**From:** Jill Bastow  
**Sent:** 22 June 2015 15:42  
**To:** Planning  
**Subject:** FW: York House Caravan Park  
**Attachments:** 777.20150618.SK001a.pdf

**From:** Chris Megson  
**Sent:** 18 June 2015 11:21  
**To:** Jill Bastow  
**Subject:** FW: York House Caravan Park

## York House Caravan Park Bank Lane Whitby Proposed Access Road Arrangement

DWG. 777.20150618.SK001

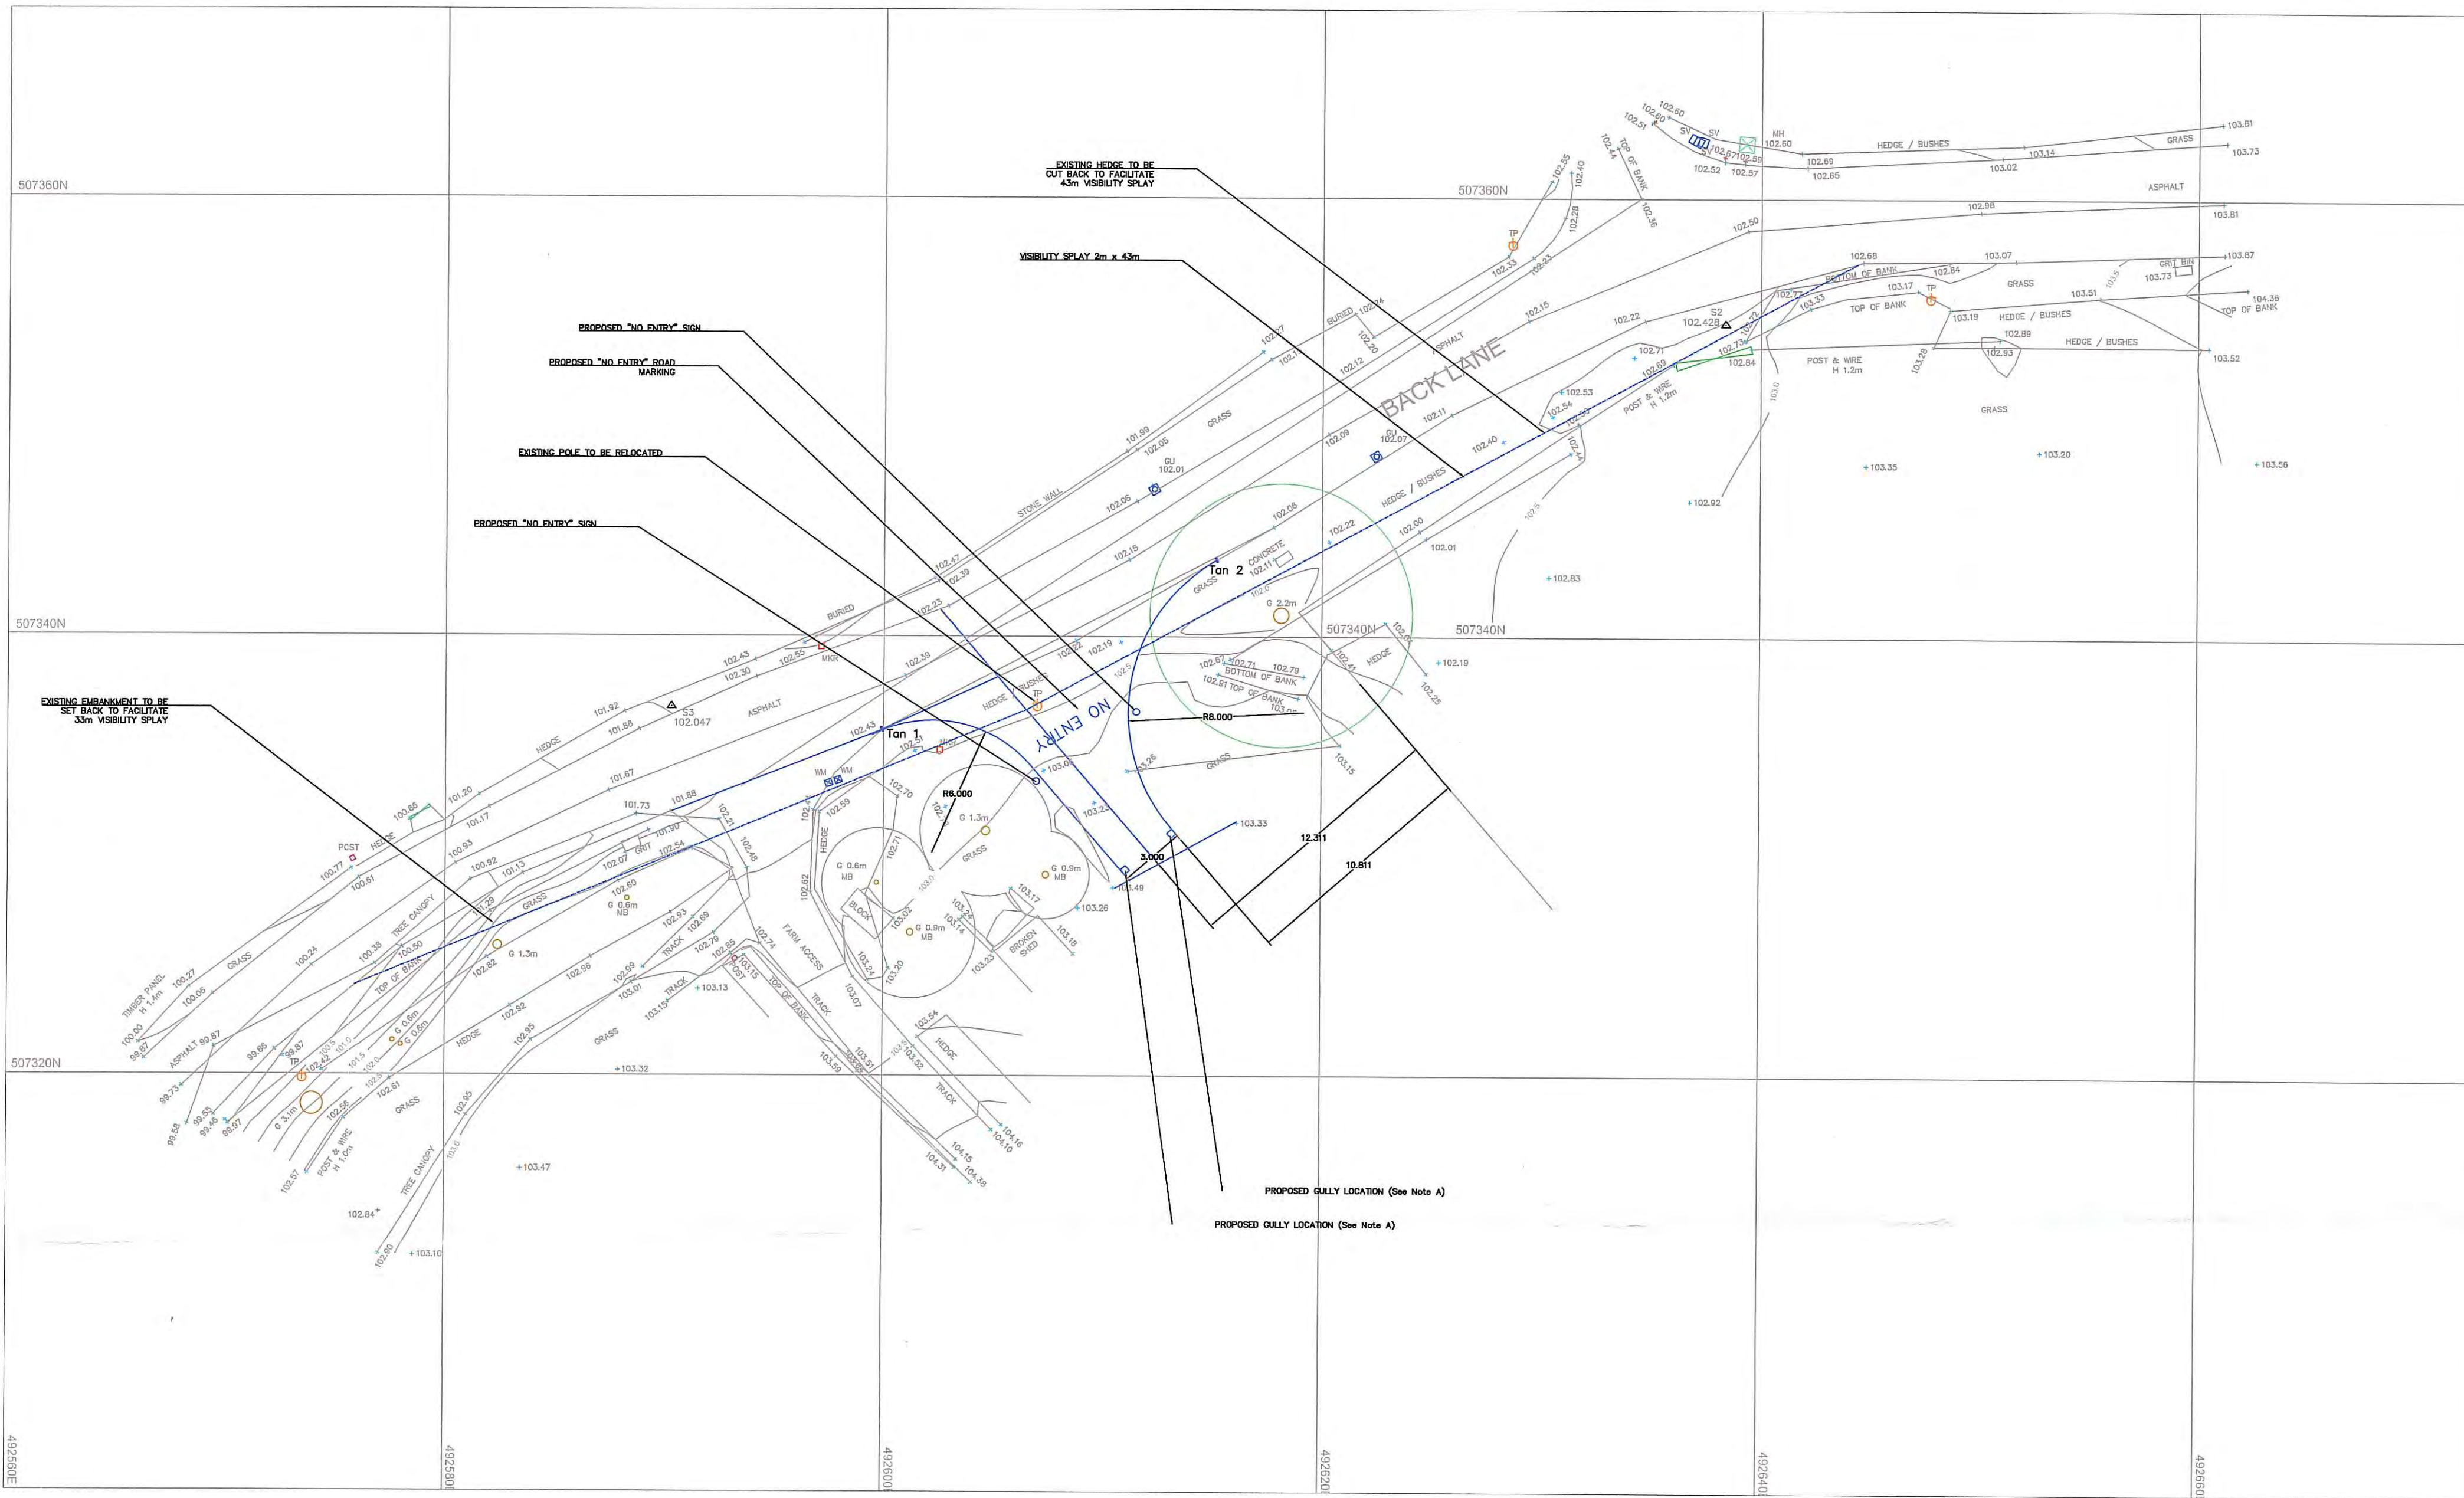
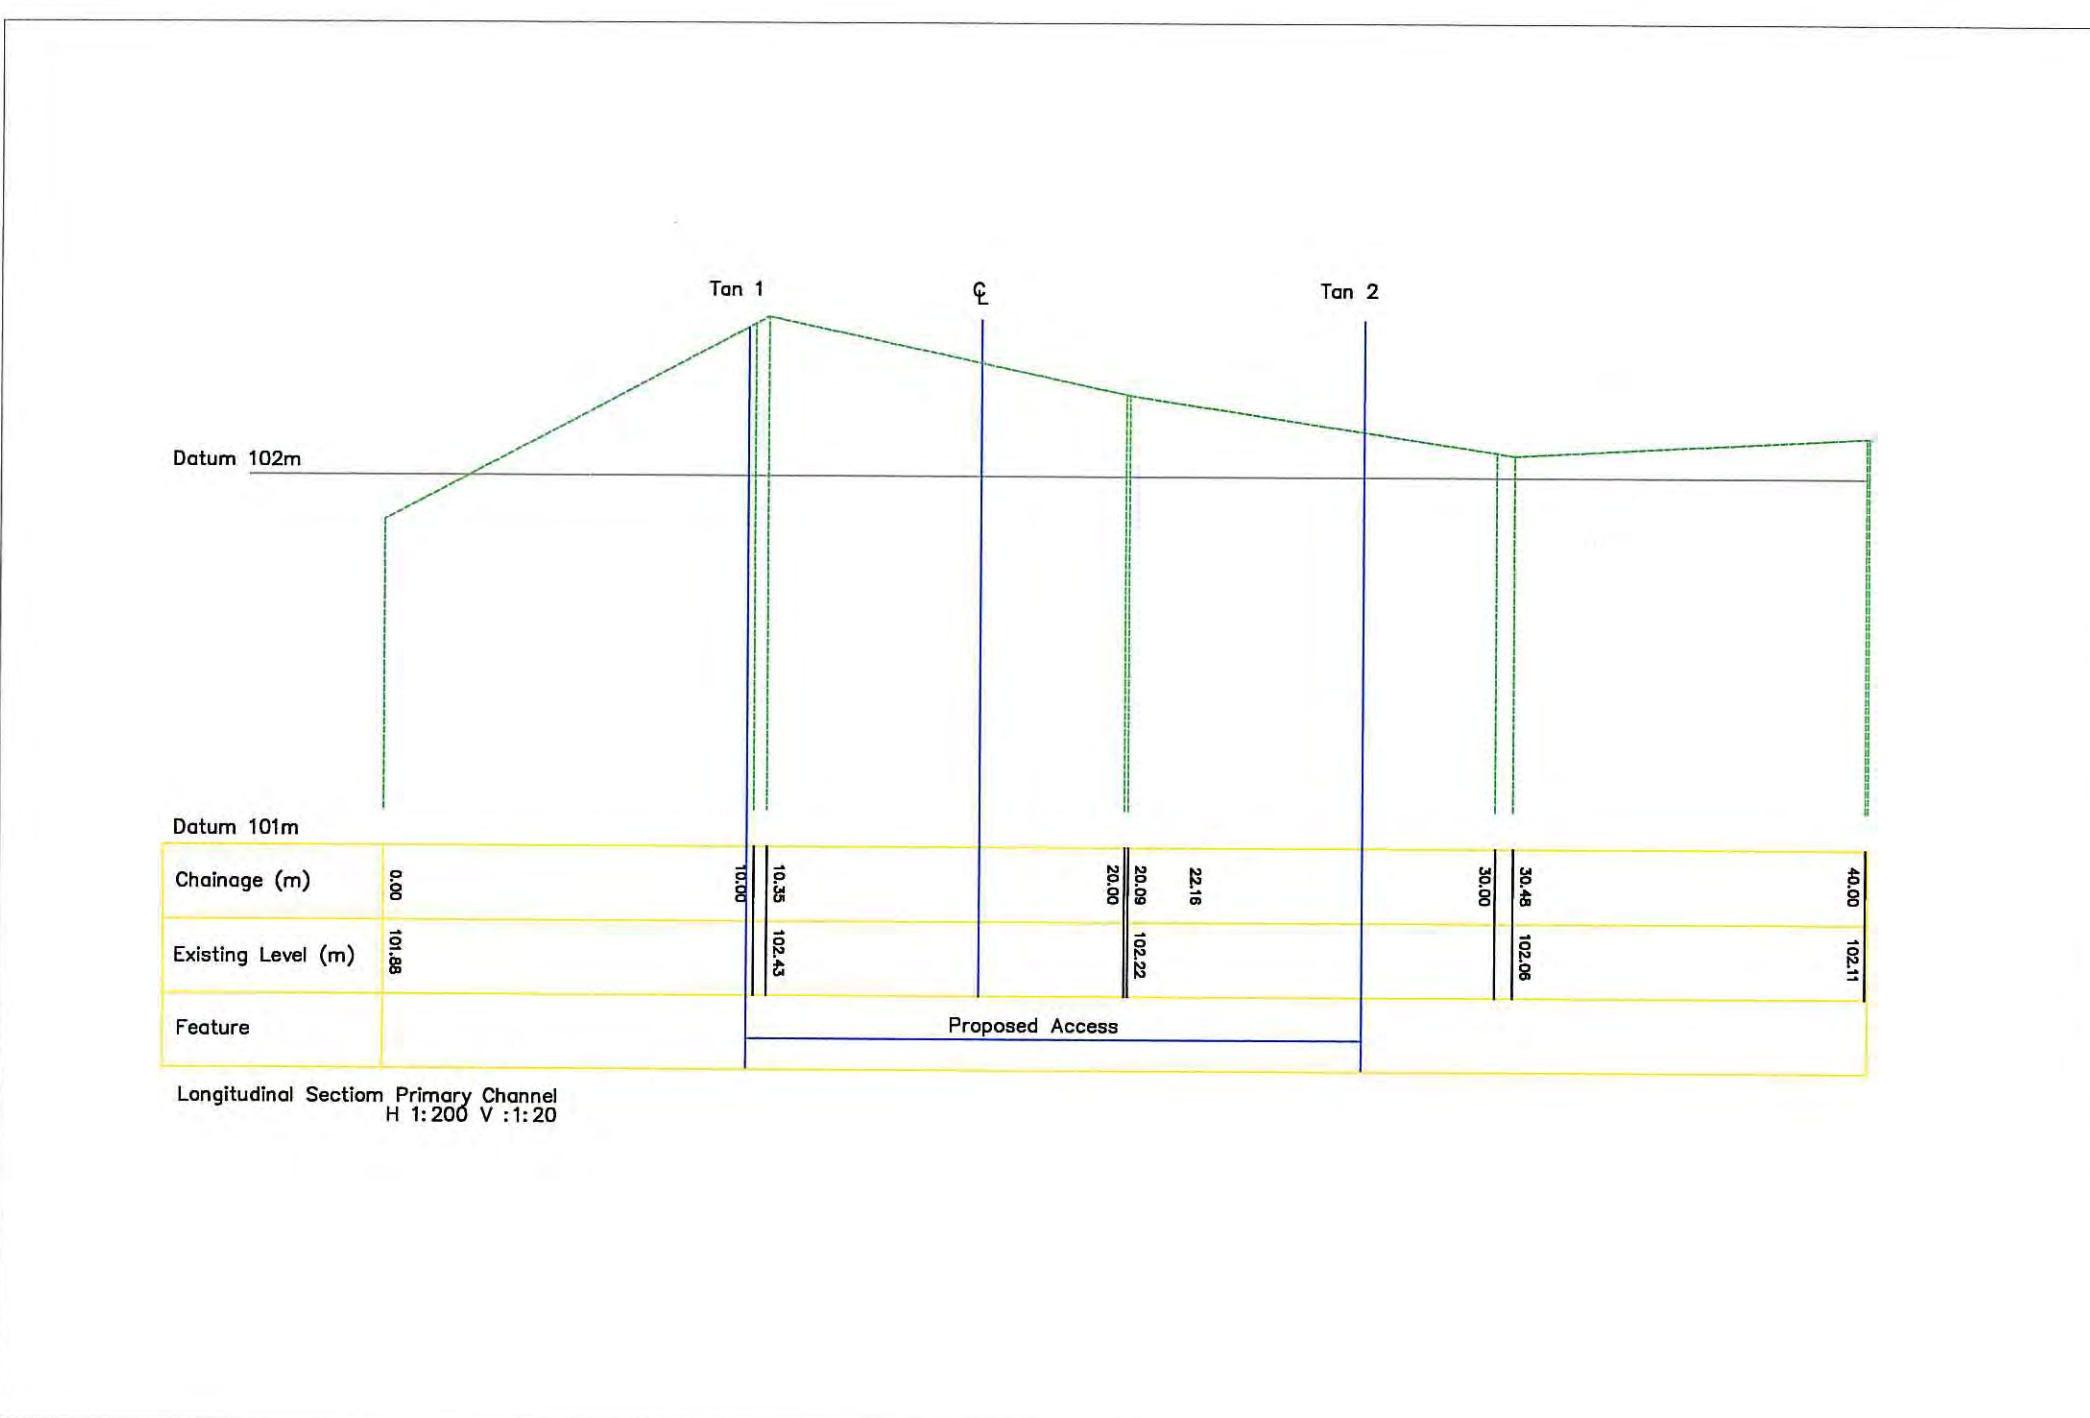
As discussed, please find attached the layout drawing showing the revised location of the proposed access. The relocation of the access is as a consequence of meeting the highway authorities requirement to achieve a 45m visibility splay to the right, in fact, we can only achieve 43m without impacting on third party land.

In order to achieve to the 33m to the left, the splay encroaches into the adjacent access which, as we discussed is assumed not to be third party land. The level difference is such, however, that the embankment will need to be set back and potentially retained.

With regards to the surface water discharge and reference to the Yorkshire Water correspondence, there is no capacity to discharge into the existing surface water system. In any event, however, the hierarchy for discharge is to soak away, infiltration system and then to a watercourse. Testing of subsoil infiltration and soak away design will be required to be submitted and agreed with the drainage and highway authorities.

There is also a requirement, as a consequence of the re-sited access, to relocate the telegraph pole. The relocation and siting will need to be agreed with the British Telecom. It is advisable the Utility enquiries are undertaken to establish the implications of the providing the access on all services including electrical, communications and gas infrastructure. Diversions/protection of these services may be required in order to facilitate the access.
